<b>Development Application:</b>	A006149162
<b>Property Location:</b>	96 Goldieslie Road, Indooroopilly QLD 4068
<b>Property Description:</b>	Lot 4 on RP803072
<b>Development:</b>	Request to Change a Development Approval under Section 81 of the Planning Act 2016 – A006149162
<b>Client:</b>	NICHOLSON GOLD PTY LTD

As prescribed under Section 78 of the *Planning Act 2016* ("PA") we hereby make a formal request to change the Development Approval A006149162.

Figure 1 – Approved Communal Recreation Space

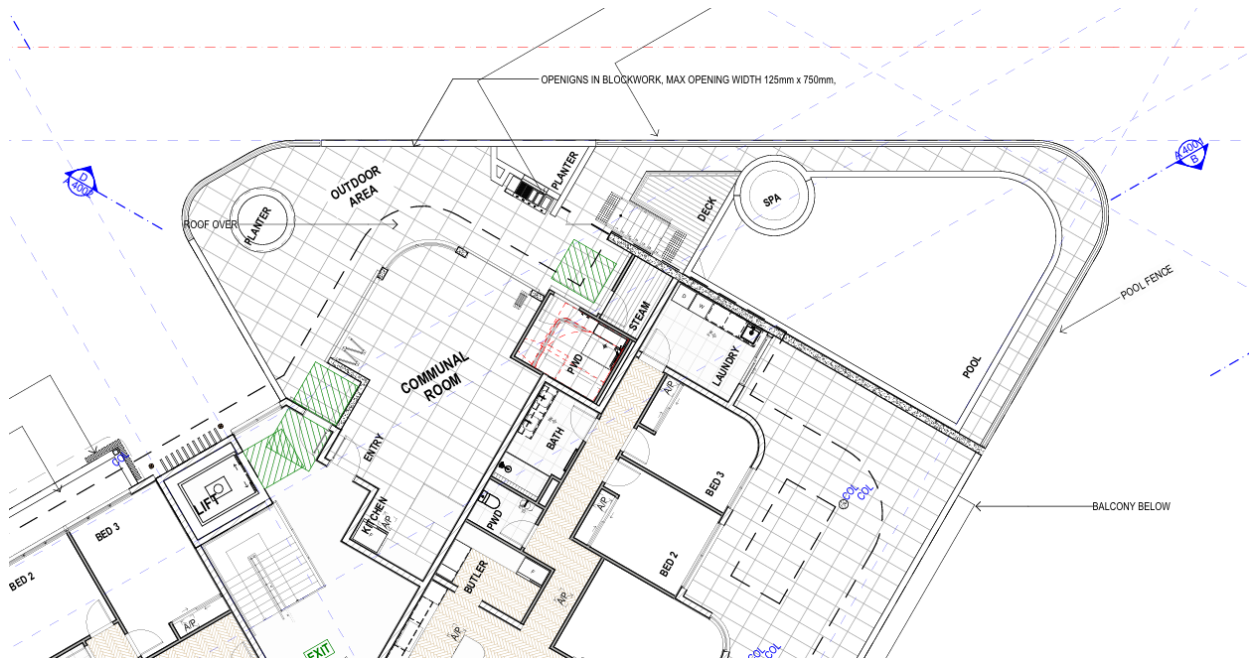
The approved communal recreation area includes a steam room, Spa, Pool, courtyard and under cover area. The space remains generally consistent with the approved plan, with slight changes to allow a direct entry door to the communal room and separate door to the courtyard and pool/spa. The location of the PWD has also been amended to adjoin the Steam room. The Pool now includes a staircase for entry, with steps to the pool deck. Refer Figure 1 and 2 below

Figure 5 – Amended Fire Pump Room

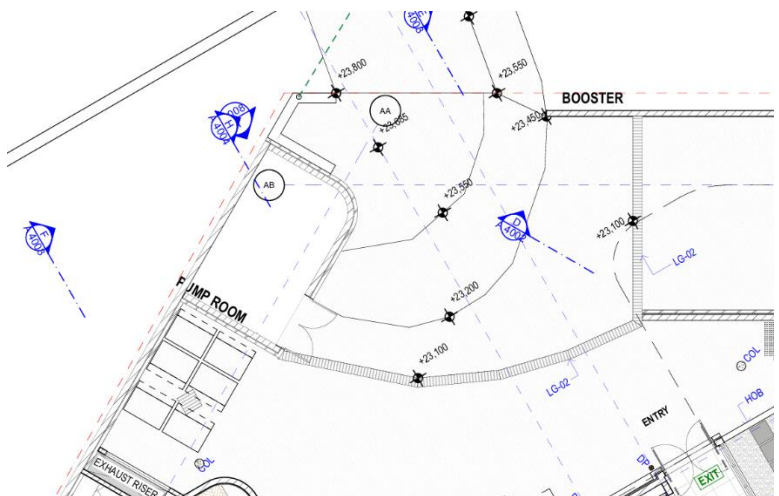
The originally approved fire pump room has been expanded in the revised plans. Despite the increase in the area of the fire pump room, the location remains the same as originally approved, and external design choices have been made to minimise the impact on the amenity of the site and neighbouring sites. The proposed pump room includes face brick and a rooftop capping to provide articulation.

Brick fencing along the perimeter of the site is included and will block the fire pump room from being seen from the Goldieslie Street frontage. The expansion of the fire pump room also required the removal of a landscaped area at the front of the site, however landscaping has been included on the roof of the pump room instead. This improves the amenity of the pump room further, and will give the impression of a garden bed when viewed from Goldieslie Street or when viewed from above from adjoining sites. This roofed landscape area also provides an increase in vegetation from the landscaped area as originally approved.

Figure 6 – Proposed Landscaping on Amended Fire Pump Room Roof

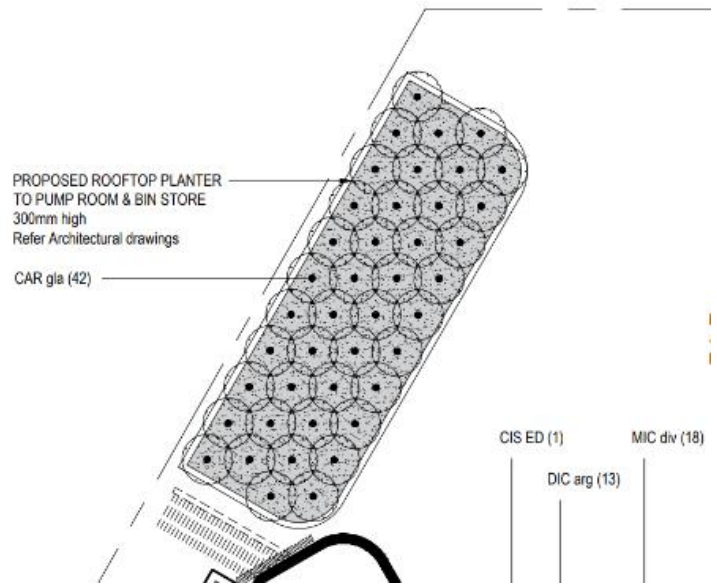
This area also includes the retention of the front facade nib wall for a letterbox feature wall. Refer Figure 5 and 6 below.

Figure 7 – Proposed Pot planting and MSB

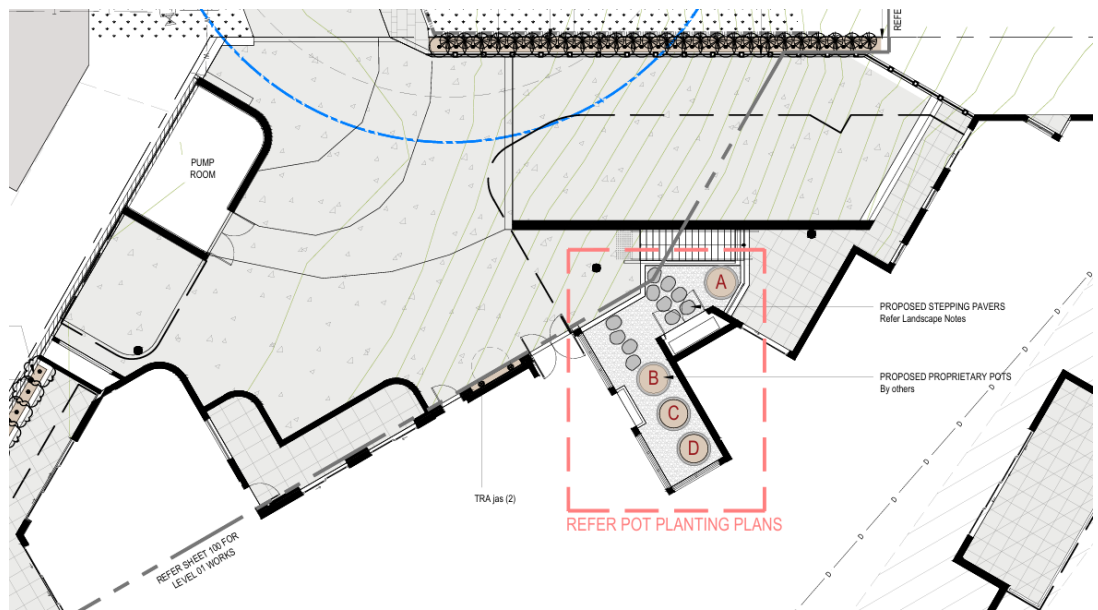
As part of detail design, landscaping has been refined. Where addressing the street, the proposal includes realignment of the entry planting adjacent Unit 6, with courtyards provided, with a main switch board and emergency stairs provided from the car parking level. The planting strategy in this area, which is under roof, is to include proprietary pot planting, in addition to feature stepping pavers, to soften the switch board, refer Figure 7 below.
